## Technical Memorandum

**Project:** 20-2737.0402

**Re:** Water System Capacity Analysis – Tualatin Industrial Park

**Figure 1. Proposed Industrial Development Site and Water System Infrastructure**

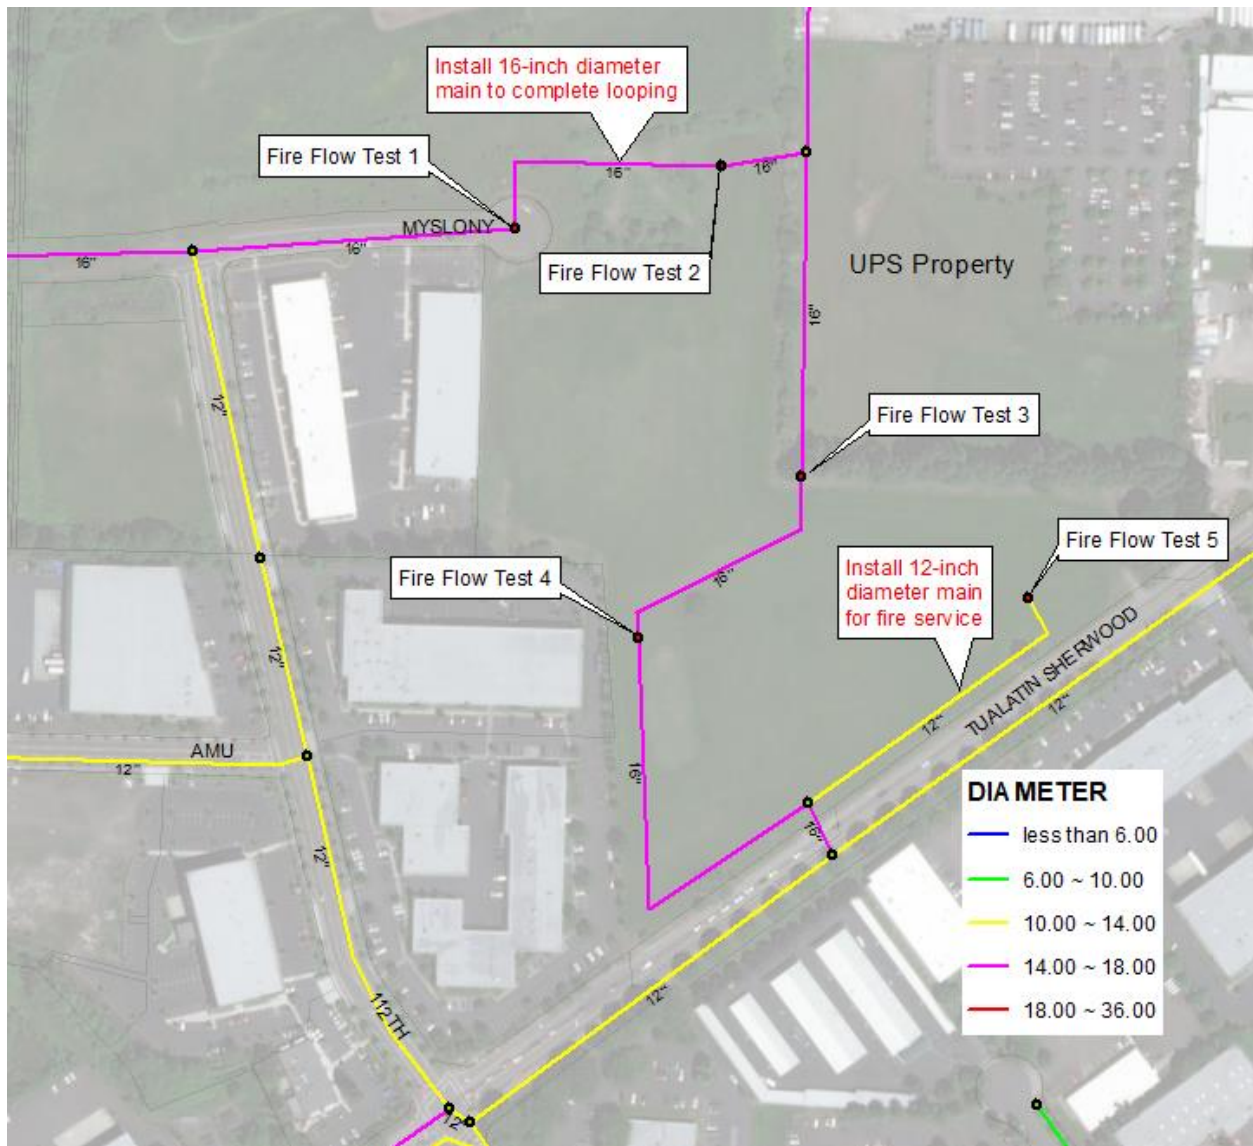
The hydraulic model was updated as described above and fire flow performance tested at five locations onsite (shown in Figure 1).

The proposed 8-inch diameter main parallel to Tualatin-Sherwood Rd is not adequate to serve a 3,000 gpm fire flow. *Upsizing this main to 12-inch diameter improves residual pressures to acceptable levels.*

Based on the findings of this analysis and a review of overall system improvement needs presented in the Water System Master Plan, there are no required water distribution system improvements not located on the Industrial Site necessary to serve domestic and fire suppression flows to the proposed development. *Proposed 14-inch diameter piping should be re-sized as 16-inch diameter piping to complete a 16-inch diameter distribution system loop.* Proposed 16-inch diameter piping finishes the looping provided by the 16-inch diameter main at the back of the UPS property, the 16-inch diameter main located on Myslony St, and the 12-inch diameter main in Tualatin-Sherwood Rd. This network is adequate to serve the required fire flow for hydrants off these new 16- inch diameter mains and continue to meet flow and pressure requirements for the surrounding area without further improvements. Completion of these required extensions and connections at the size indicated is the minimum size required to meet fire flow requirements for the proposed development.
